INITIAL FIRE SAFETY INSPECTION REPORT

Chancellor Garments Ltd. (relocated)

RSC ID: 25554

Date: 04/03/2024

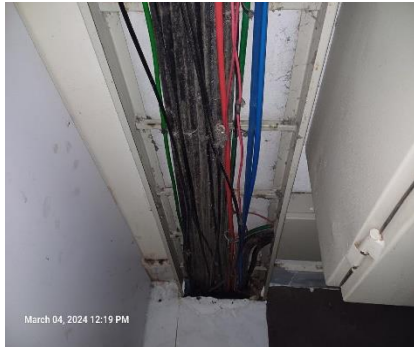
SI No.		Findings	Required Action	Remediation Time Frame
F-1	Fire Rated Construction	The exit stair enclosures are not separated from work areas and other spaces on each floor by fire-rated construction. Location: Building 1, 2 & 3.	The exit stair enclosure shall be provided with a minimum 1-hr fire resistance rating for buildings with 3 or fewer stories and a minimum of 2-hr. fire resistance rating for buildings 4 or more stories. Provide 0.75 hr. fire rated door and seal all penetrations and openings by 1 hr. fire rated fire rated barrier construction for building with 3 or fewer stories. Provide 1.5 hr. fire rated door and seal all penetrations and openings by 2 hr. fire rated fire rated barrier construction for building with 4 or more stories. Provide a fire-resistive rated assembly between the exterior exit stairs and the building up to 10 ft. beyond the end of the stair to achieve the required separation. The rated assembly shall be approved and/or designed by a qualified fire protection engineer. Ensure that the fire doors are self-closing and positive latching and that they are provided with fire exit (panic) hardware where serving production floors. If fire doors are required to be held open for functional reasons, provide automatic closing devices tied to the fire alarm system.	Within 3 Months

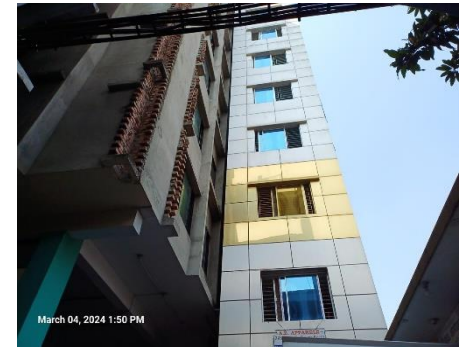
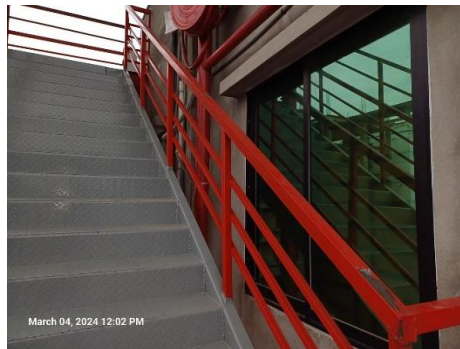
F-3	Fire Rated Construction	Elevator shafts are directly open inside the floor. Location: Building-1 & 2.	Ensure the lift shaft is enclosed by a minimum 2-hour fire rated wall with minimum 1.5-hr fire rated opening protection. Recommended to follow "SUPPLEMENTARY PAPER ON REMEDIATION GUIDANCE ELEVATOR OR LIFT SHAFT OPENING IN EXIT ENCLOSURES" for remediation.	Within 3 Months
March 04, 2024 12:00 PM March 04, 2024 12:38 PM March 04, 2024 12:29 PM				
F-4	Fire Rated Construction	Unsealed penetrations and openings are located in the exit stair enclosures.	Seal all penetrations and openings in exit stair enclosure walls to maintain the fire separations.	Within 3 Months

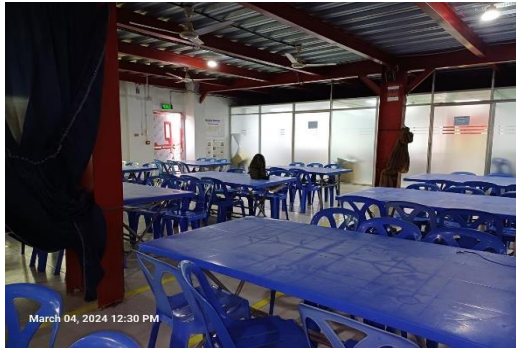
F-7	Fire Rated Construction	Areas used for combustible storage are not separated by fire rated construction. Location: Building 1 and 2.	Provide defined storage areas and limit the storage arrangement as follows:- 1. General Condition: Maximum height of 2.4m and maximum area of 23m². Separate areas of unenclosed combustible storage by a minimum clear distance of 3m. 2. If sprinkler protected: maximum height of 3.66m and maximum area of 93m². Separate areas of unenclosed combustible storage by a minimum clear distance of 3m. 3. Enclose the storage area from the surrounding occupancy with a minimum 1 hour construction.	Within 3 Months

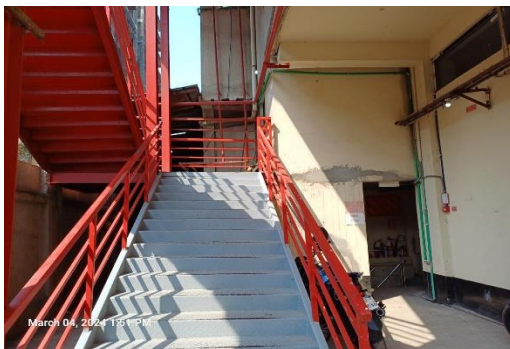
F-9	Fire Rated Construction	The fire pump room is not provided with adequate fire separation.	Provide fire pump room with 2 hr rated fire separation when not sprinklered and 1 hr rated fire separation when provided with automatic sprinklers in accordance with NFPA 20 Or, Physically separate the pump room from the protected building by a minimum of 50 ft. (15.3 m) in accordance with NFPA 20	Within 3 Months

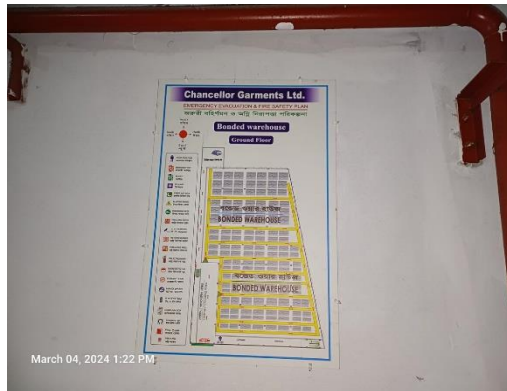
F-15	Means of egress	The width of all the exit stairs are less than 1.5 m (60 in.).	In new and interim construction and constructed stairs post 24 November 2013, stairs shall have a minimum width of 1.5 m (60 in.) for all industrial occupancies and 2.0 m (79 in.) for all assembly occupancies. For assembly use areas provided for prayer halls, dining halls and like areas that are for integral use by the factory workers, the minimum width for the primary occupancy use of the building shall be permitted to be used.	Within 3 Months
F-16	Means of egress	Common path of egress travel exceeds 23 meter in Ground floor of Building 03.	Reconfigure the egress arrangement to reduce the maximum common path of travel to not more than 23 meter.	Within 3 Months

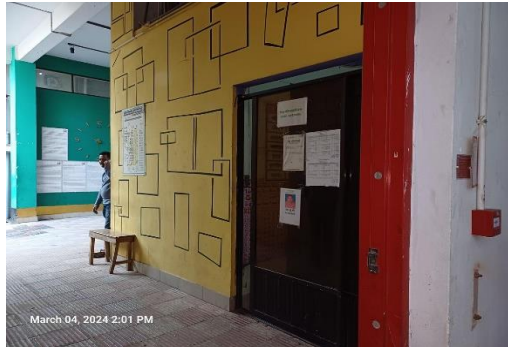
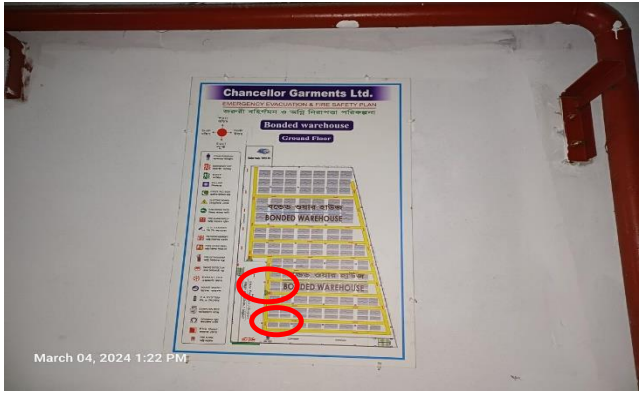
F-22	Means of egress	Sliding doors are provided at building exits.	Replace all collapsible gates/ sliding doors/ rolling shutter doors along the means of egress with side-hinged, swinging egress doors. If locks are required for security reasons, utilize specialized door locking features complying with NFPA101.	Within 1 Month
------	-----------------	---	--	----------------

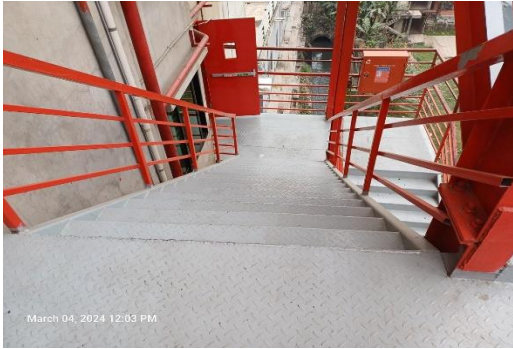
F-24	Means of egress	The travel distance is exceeded the limit on the Ground and 1st floor of the Building 3.	Maximum allowable travel distance is required to be according to RSC Technical Guidelines (Standard) Section 6.13.1.	Within 3 Months

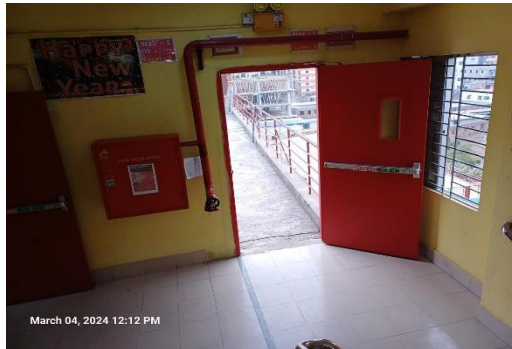
F-31	Inspection Testing and Maintenance of Fire Alarm and Detection System (ITM)	Inspection, testing and maintenance for the fire detection and alarm system was not in accordance with standard.	Inspect, test and maintain the fire alarm system and keep written records on-site, in accordance with Table-14.3.1 of NFPA 72.	Within 1 Month (after installation)
F-32	Fire Protection System (Standpipe)	Standpipe system installation requires detailed review to confirm compliance with NFPA 14, 20, 22, & 24 or as per RSC Technical guidelines (Standard). Location: Building 1, 2 & 3	Submit the standpipe system drawing to RSC for review. Once the design is reviewed, install/ modify the standpipe system throughout the building in accordance with review comment, RSC Standard and NFPA 14, 20, 22 and 24. After installation the owner shall conduct internal testing and commissioning and then contact the RSC for witness of final acceptance testing.	Design within 2 Months and modification (If require) within 4 Months.
